Location Address: 5701 Pembroke Rd Hollywood, FL 33023

SUBJECT: Preliminary Site Plan review for a building of approximately 5,250 square feet.

City of Hollywood
Division of Planning and Urban Design
Technical Advisory Committee
2600 Hollywood Boulevard, Room 315
Hollywood, FL 33022-9045

SITE PLAN

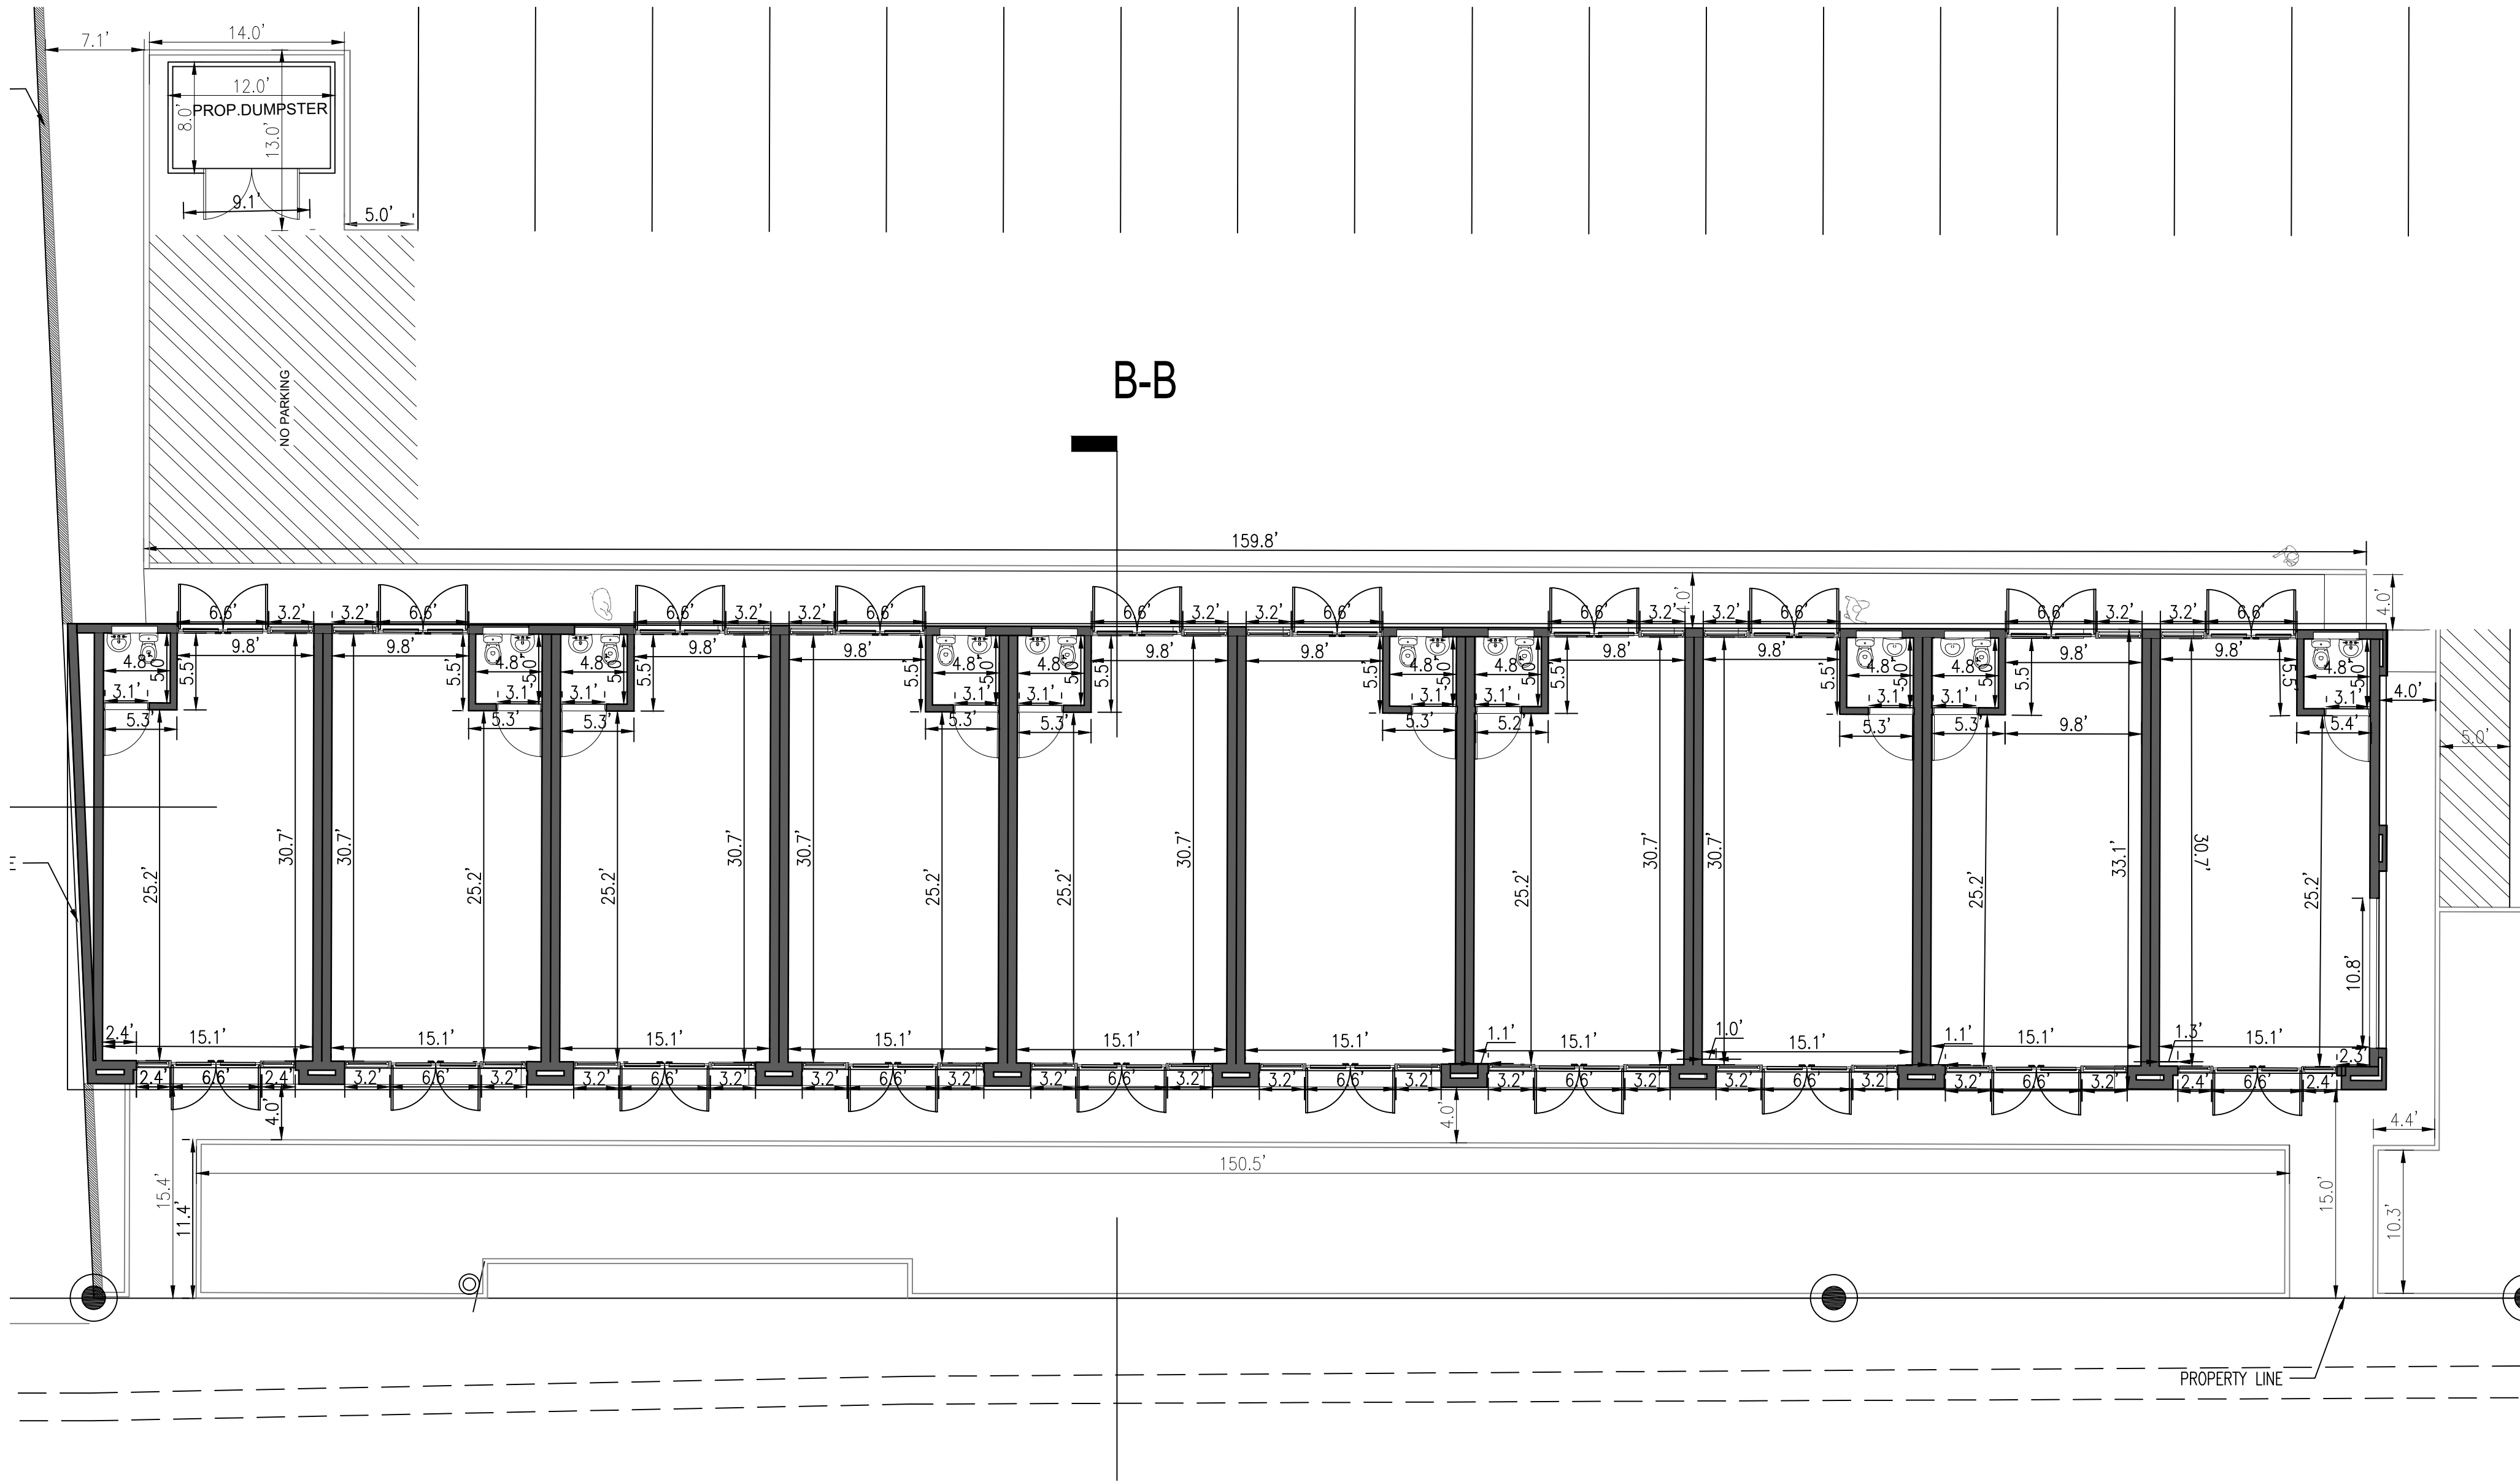
- B. The front setback required is 15 ft. and the rear setback adjacent to a residential district is 15 ft. DONE
 - Acknowledged. On the zoning legend, it specifies the 15.0 ft. setbacks required, front and rear, alongside the provided setback specifications: 15.0 ft. for the front setback and 56.0 ft. for the rear setback adjacent to a residential district. The distances have also been specified in the site plan.

- C. The queuing of the vehicles at the entrance and exit shall not block a parking space. DONE
 - Acknowledged. Please refer to the site plan SP-01.
 - D. The two-way drive shall be 24 ft. min. DONE

- Acknowledged. Below parking space #13, the circled line indicates that the two-way drive measures 24.0 ft., as specified on the site plan.
 - E. Provide visibility triangles at all driveway accesses. Indicate the curbing around the parking spaces. Wheel stops are not necessary. DONE.

- G. Dimension of ADA shall be 12 ft. plus 5 ft. stripe area. DONE
 - ADA specification can be noted through symbol on lower right hand corner of the site plan. The 12 ft. plus 5 ft. stripe area is noted as well.

- a. Visibility triangles are included on ST-1.0 at all driveway accesses.
11. Please show the corner setbacks on the site plan. Minimum City required corner setback for both the intersection of S 57th Ave. and Pembroke Road (25' X 25'). The corner setback area is the area lying adjacent to a street or alley as delineated by a line connecting points measured 25 feet distant along the property lines at the intersection of a street or six feet along the property lines at the intersection of an alley and a street. The height of bushes, hedges, fences and walls located within corner setback area is restricted to two feet.

- a. Please refer to ST-1.0.
12. On sheet ST-1.0, the parking calculation table states that 2 transit zones are provided. Please show on site plan where are the 2 transit zones located. Acknowledged,
The parking calculation table mentions 1 transit zone and it has been indicated.

13. Please identify the sidewalk on the site plan. Additionally, please indicate for sidewalk in the rights-of way to removed and replaced with new 5-foot-wide sidewalk along all frontages of the property. Sidewalks should be flush through driveway opening, provide ADA detectable warning and include detail. DONE

Sheet no.: ST-1.0 on the plans, the dumpster enclosure outlined on this sheet (labeled as "PROP DUMPSTER"), the dumpster seems to be positioned facing east directly adjacent to SW 57 Avenue. This positioning seemingly will allow the garbage truck to block pedestrian traffic on the sidewalk and possibly create vehicular challenges along the SW 57 Avenue corridor during collection periods. Requesting the applicant reposition the dumpster, allowing the garbage truck to enter onto private parcel completely to perform collection services. I realize the dumpster enclosure is not on ROW but their anticipated activities will seemingly have performance on ROW, and we can't allow it. According to the code, all collection activities shall performed on private property. Additionally, do you mind rechecking the code language as it relates to having dumpster enclosures near residentially zoned properties. I believe there is a required landscaping or civil buffer to block activity from the residents view, and if verified, I believe this construction will be directly near two (2) adjacent residential properties: 5680 Fletcher Street; and, 1650 S. 57 Avenue. DONE

- The visibility triangles can be seen next to the main entrance on the right side of the site plan and handicapped parking spot, by S 57th Avenue. The curbing around the parking has been indicated please refer to SP-01 by parking number 13.

- In the legend, under Site Area Calculations, the landscape area, or "Green Area" meets and notes the 25.00% requirement. Vehicular Use Area is under "Driveway & Parking Spaces," noted to be 40.93%. These can be seen on the site plan as well.

- a. All 5-foot sidewalks are indicated and identified on page ST-1.0, including ADA detectable warning, detail, adjacent sidewalks, and prop walkway ramp has been proposed.

TITLE:
ELEVATIONS

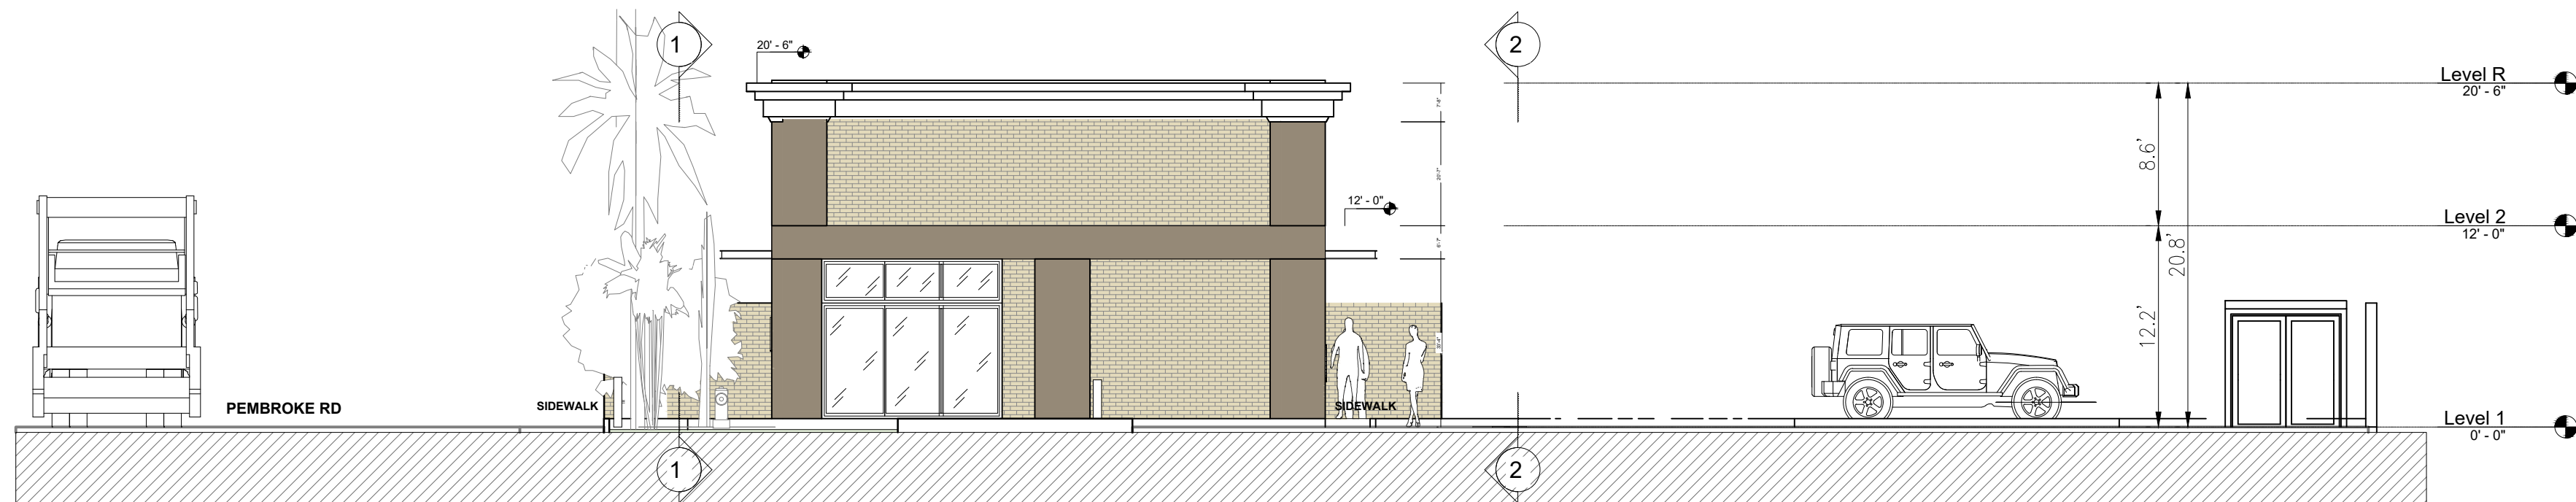
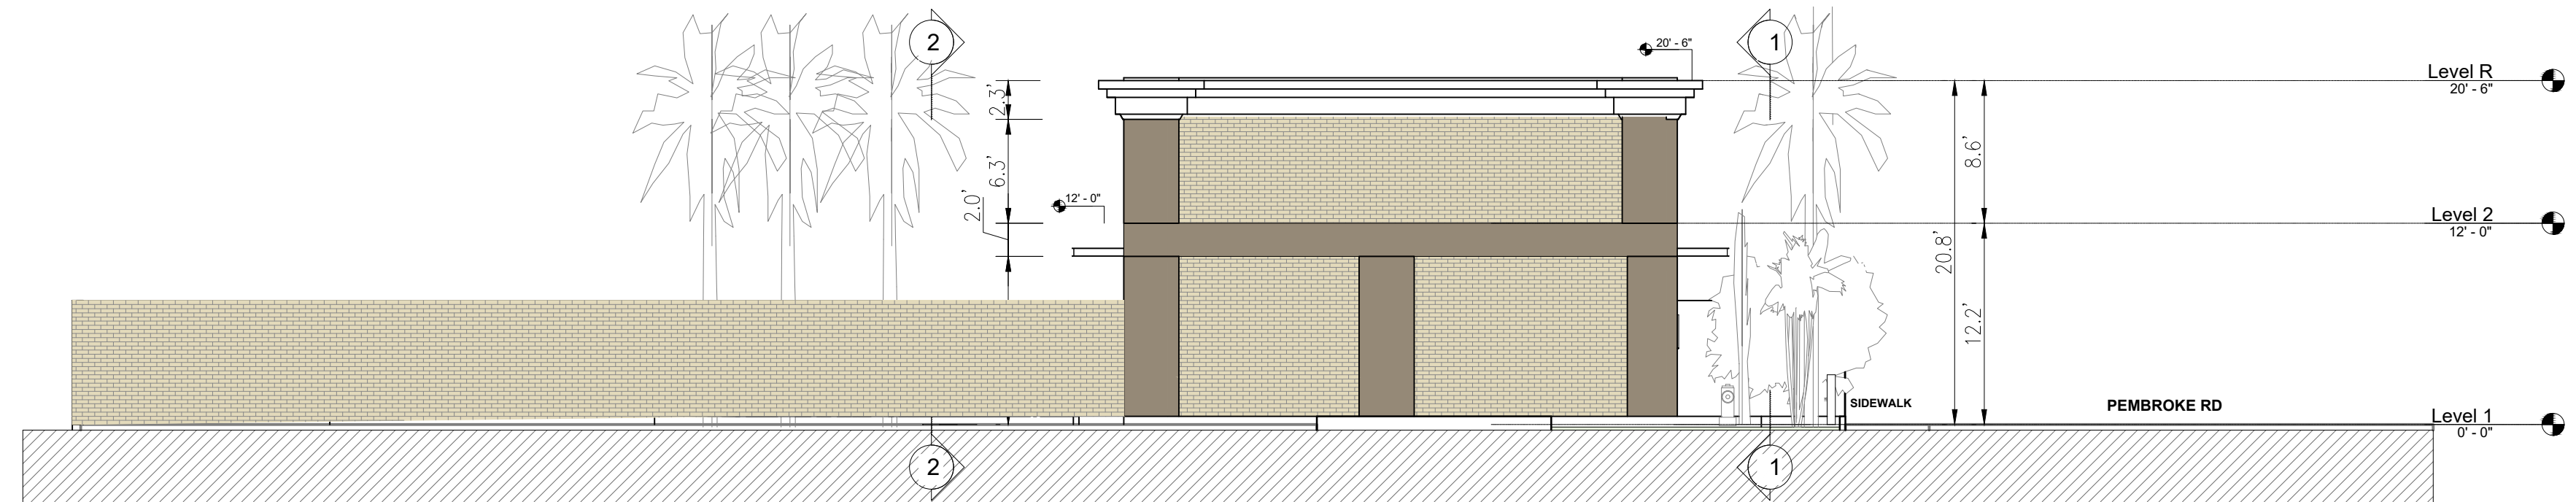
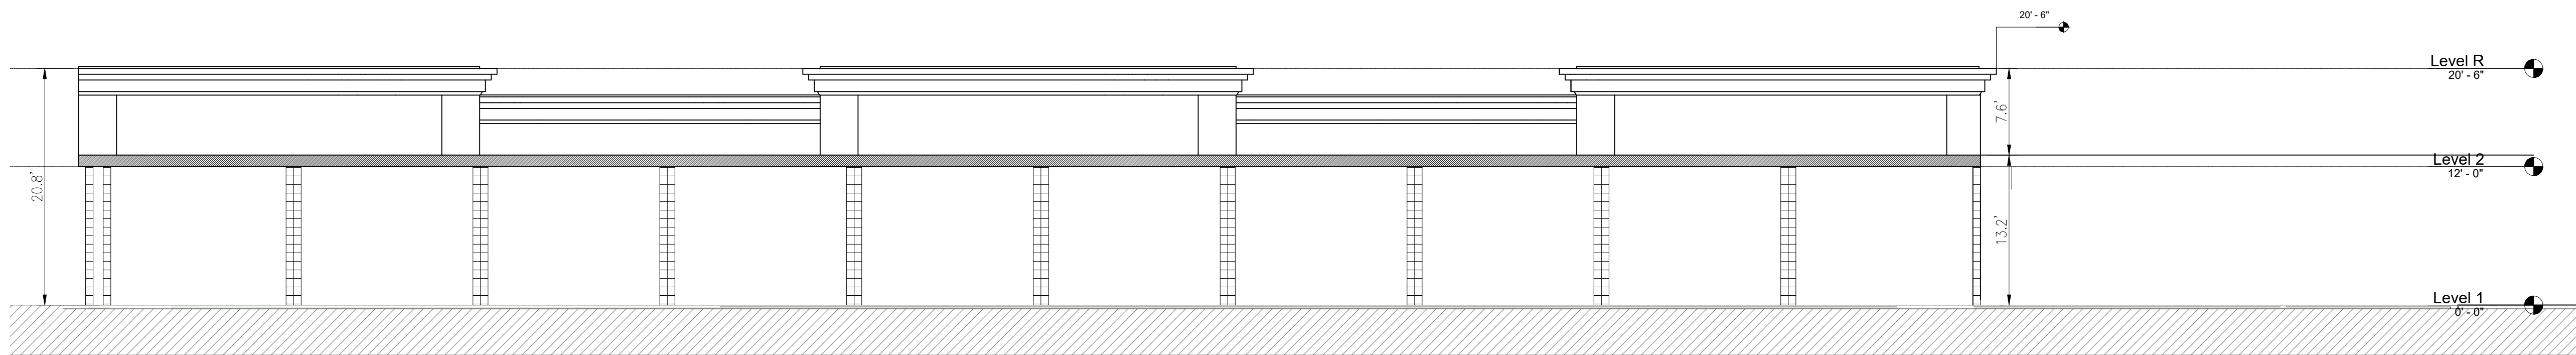
- A. Include the property lines and setbacks to the building and balconies on the floor plans and elevations.
 - o Property lines and setbacks to the building are included in the floor plan. For elevations, please refer to pages A-5.0 and A-6.0. Balconies not applicable on this project.
